Project Notebook Project: RGBSaber Version: 1

Entry: 016 Date: 4/15/2011 Version: 1.6 Title: PCB Layout v1.6 Completion

Figure 1: Overlapping via error

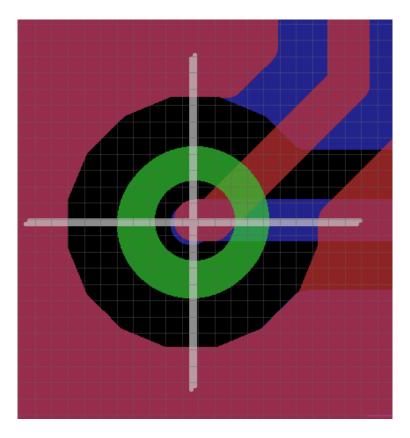
When layout was completed for the boards, I submitted the boards to FreeDFM for an analysis of the boards before sending them off to Advanced Circuits for manufacture. Multiple FreeDFM scans revealed no errors for the peripheral board but 2 issues with the control board. The first were some insufficient trace width violations. In speaking with Ben it was believed that these violations related to the border of the RGBSaber_control

PCB, which is not included in the copper layer of the PCB but could theoretically be picked up for an error nonetheless. Additionally, FreeDFM kept throwing an error for double drill hits - two drill holes that were placed extremely close together. After very careful scrutinization of the board, and talking with Ben, the source of the double drill hits, 2 almost overlapping vias, was discovered. A picture of the overlapping vias is shown in figure 1, below.

Once the errors were resolved, the designs were sent off to Advanced Circuits for fabrication. Final images of the RGBSaber_control and RGBSaber_periph layouts are shown in figures 2 and 3, below:
